From: Biazar, Shahab
Sent: Friday, November 08, 2013 8:48 AM
To: 'Trula Howe'
Subject: RE: Confirm

SANTA FE FEDERAL CREDIT UNION
GRADING AND DRAINAGE PLAN
ALBUQUERQUE, NEW MEXICO

SHEET NUMBER
C.1

Re: Santa Fe Federal Credit Union, 7101 Jefferson Street NE, Grading and Drainage Plan, Engineer's Stamp dated 06-04-2013 (D-17/D017)

LEGEND

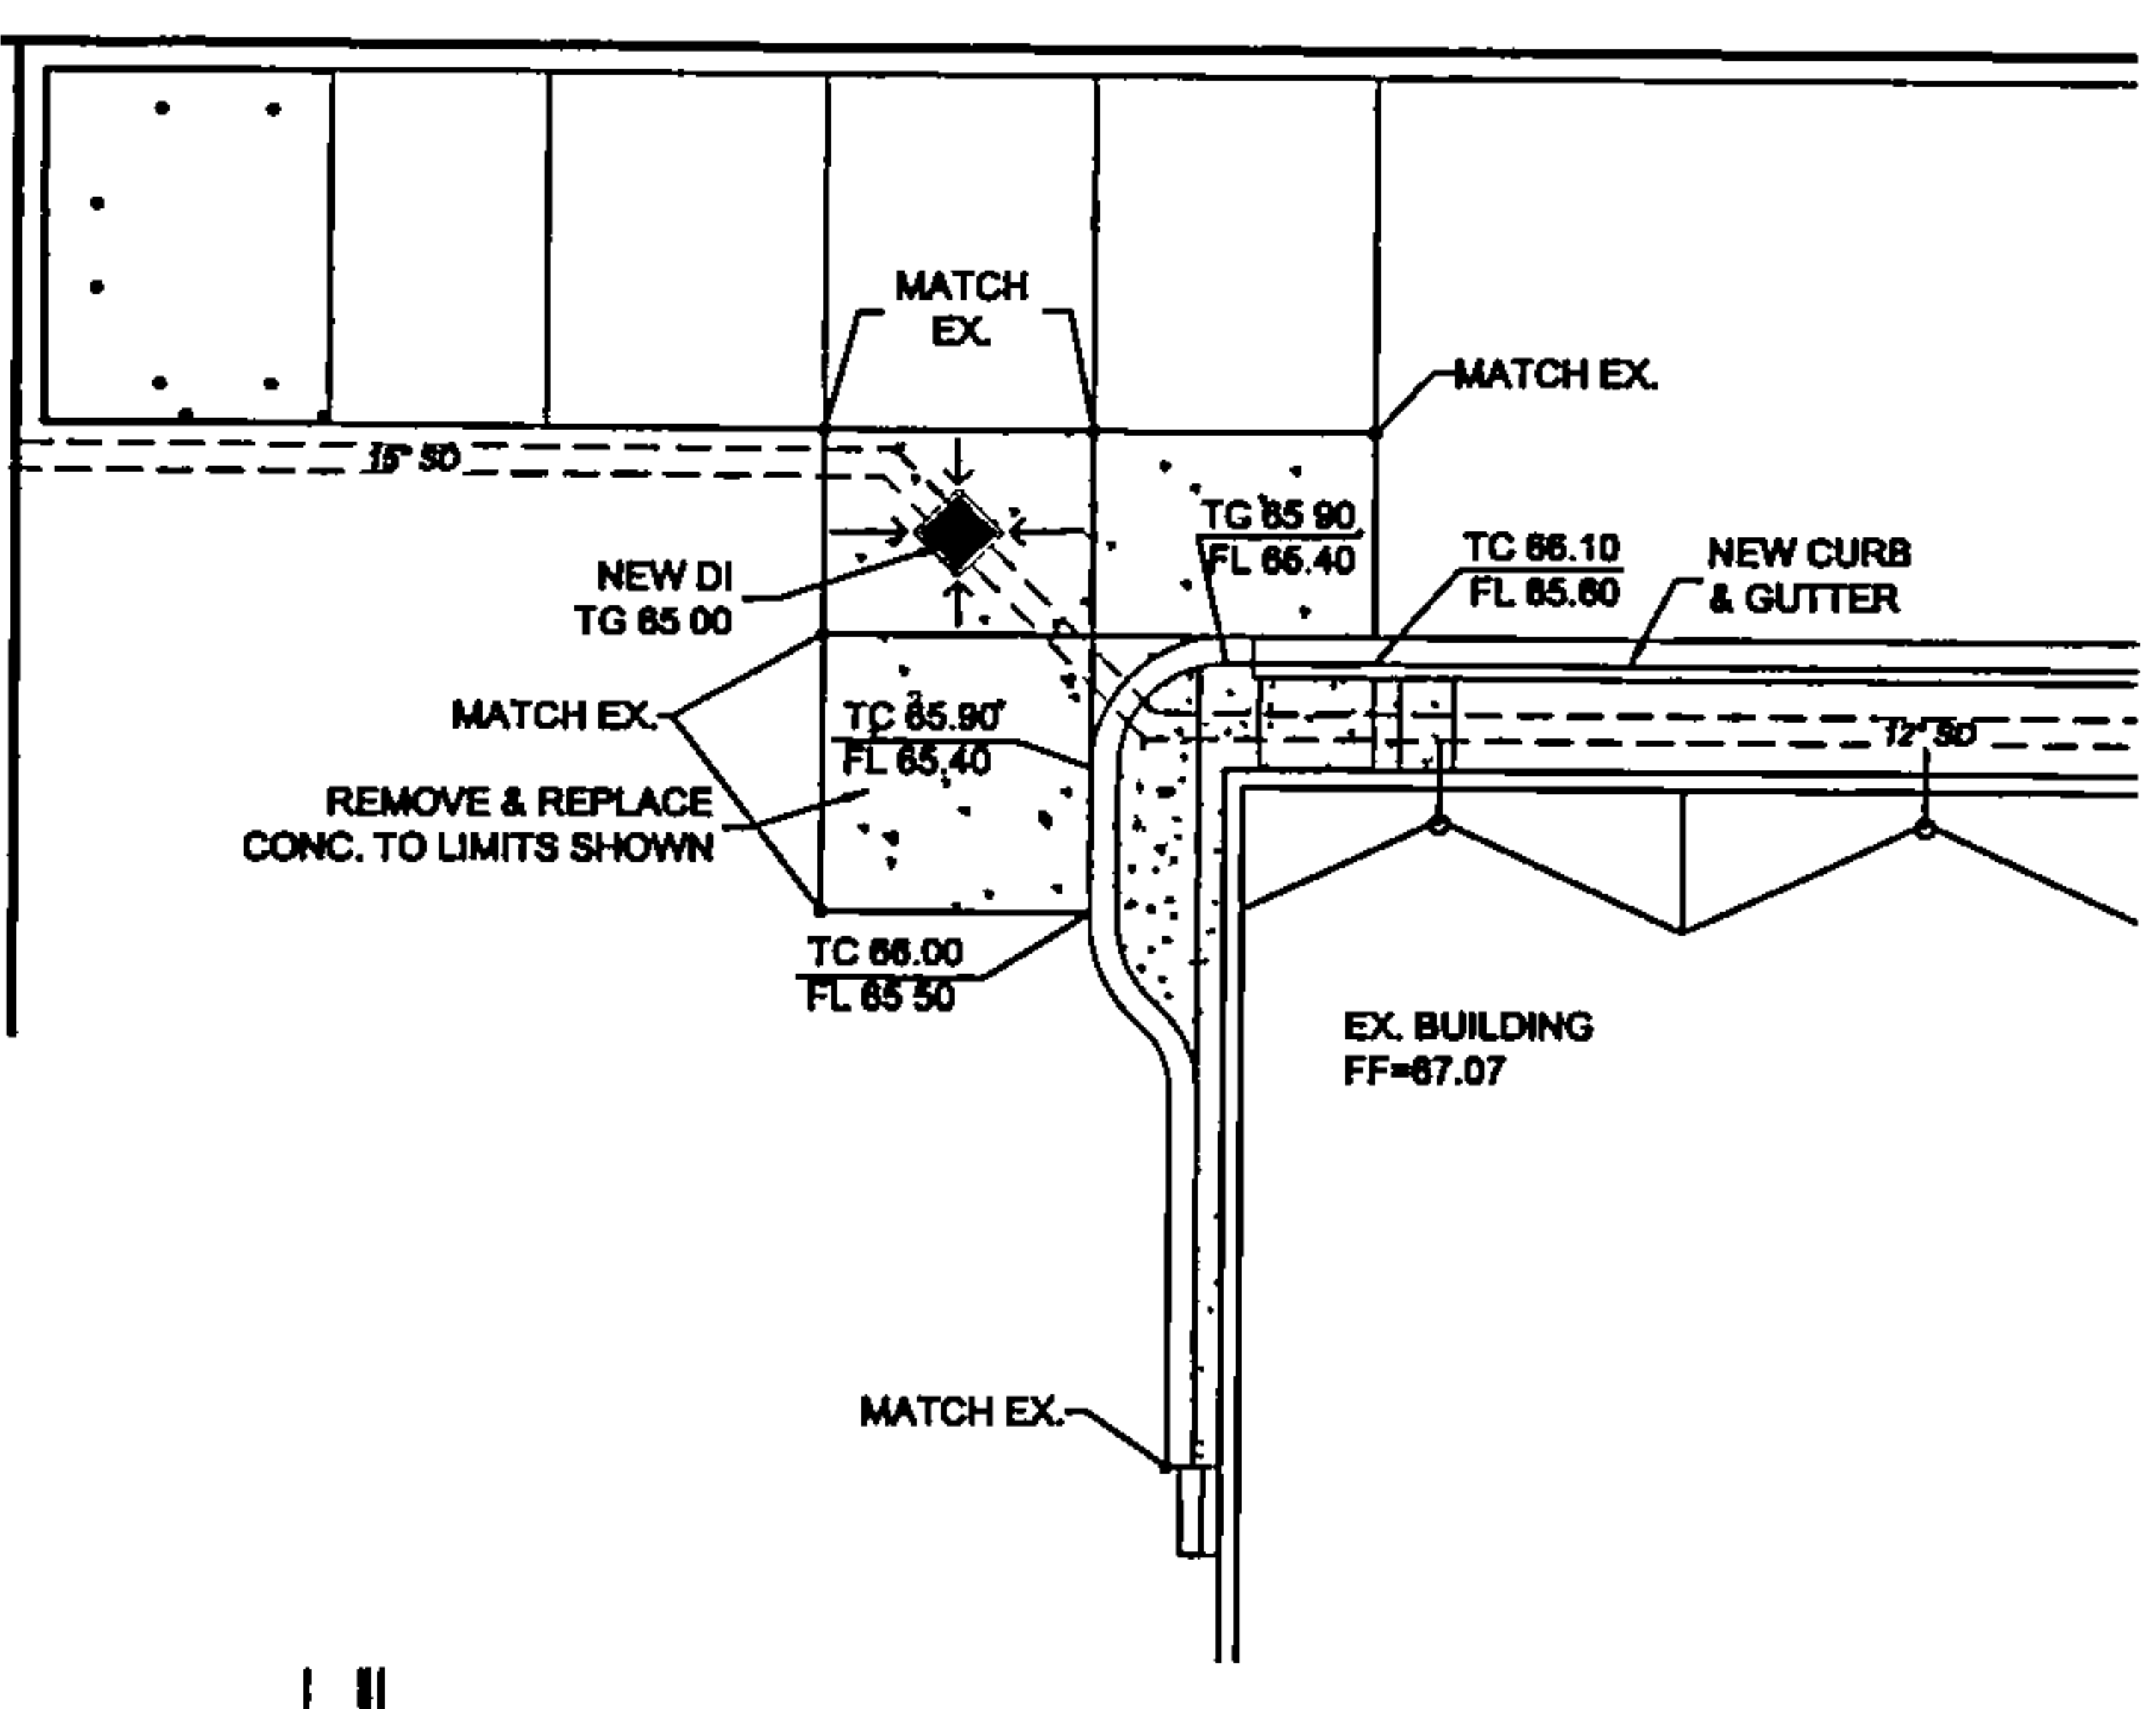
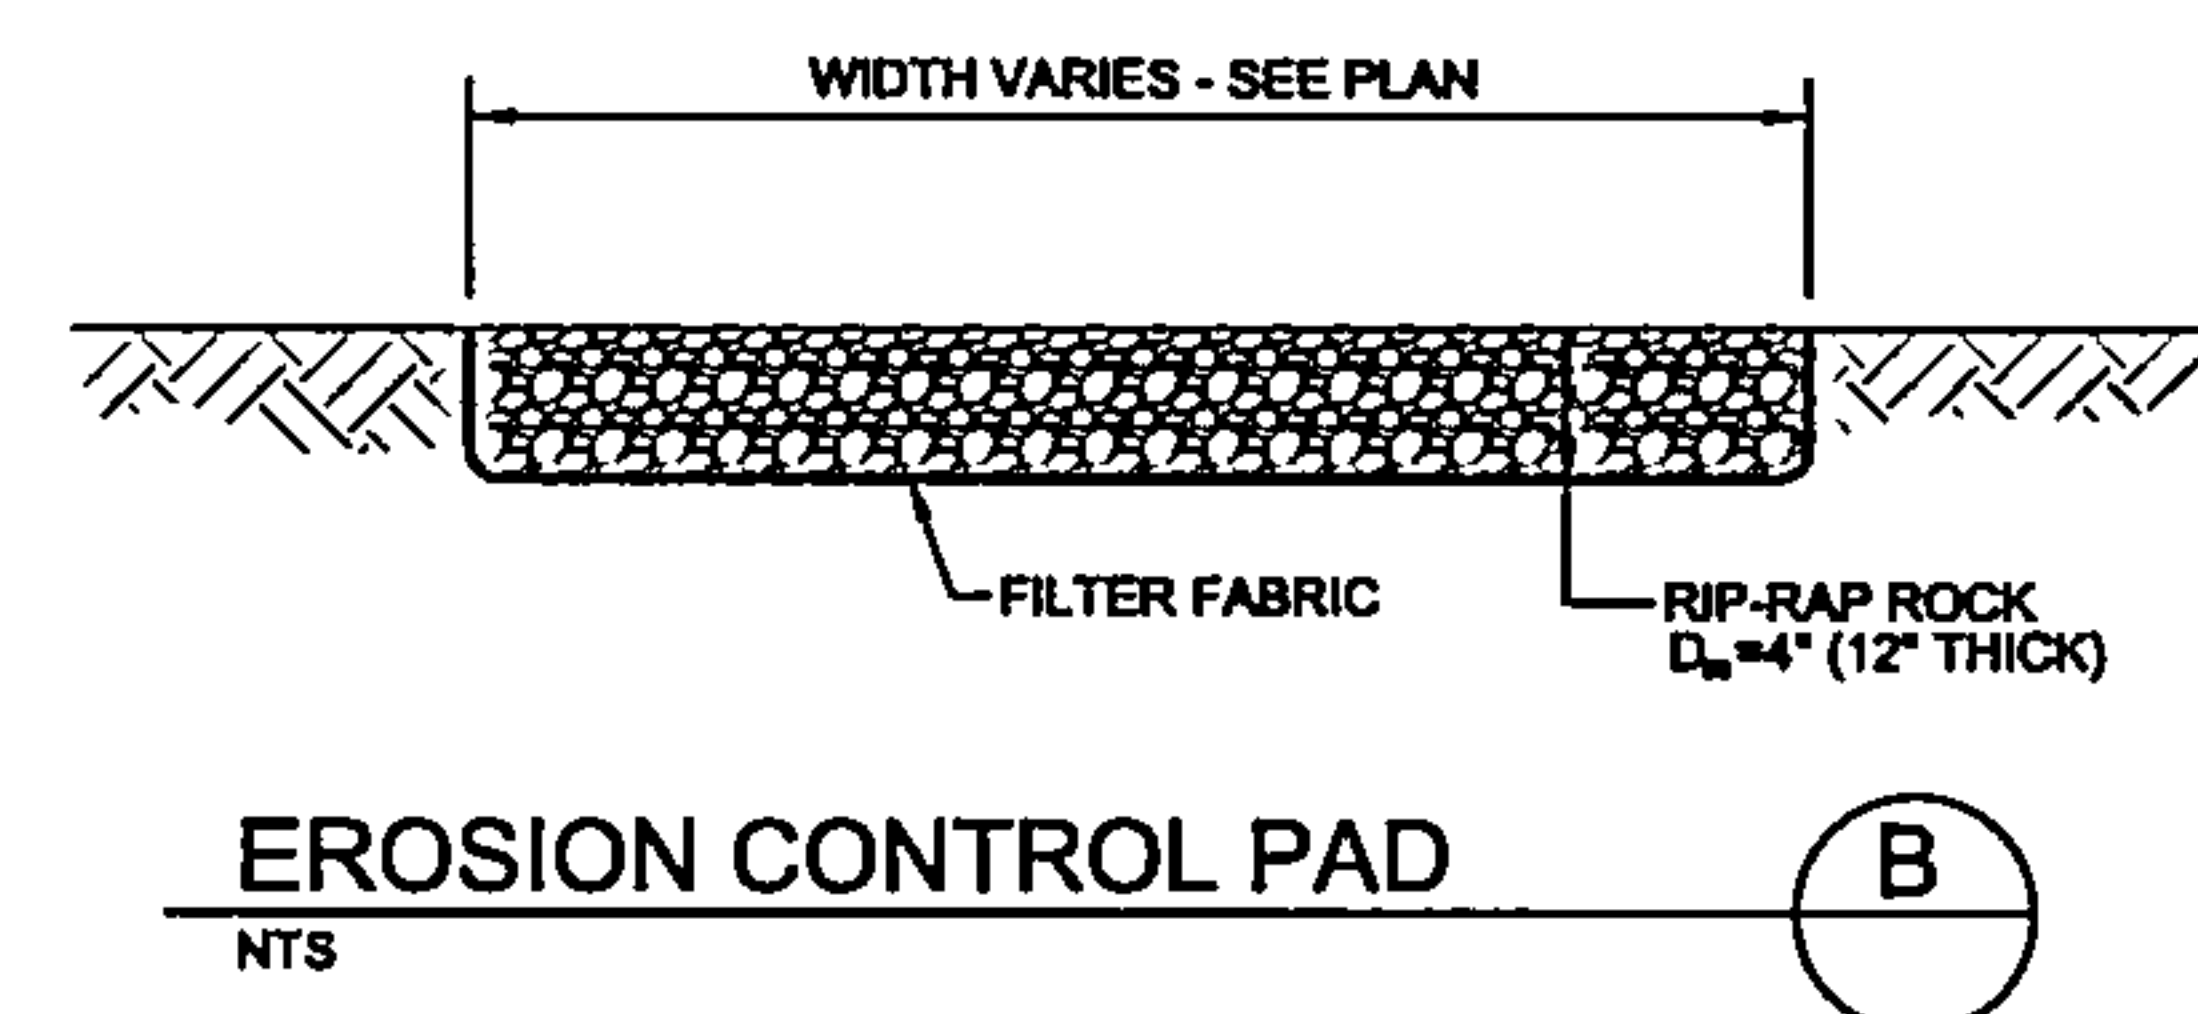
- Please quantify the offsite flows from the parking lot to the north of your project and include these flows in the drainage calculations for the existing sidewalk culvert; if over capacity address how these flows will be accommodated.
- Add a note to extend the culvert and culvert plate two feet back from the property line and to tack weld the bolts to the steel plate.
- Clarify if the existing swale is completely asphalt lined. Satellite imagery shows a significant amount of sediment in this channel.
- If the sidewalk culvert is altered please provide both an invert elevation and flowline elevations within Ellison Street.
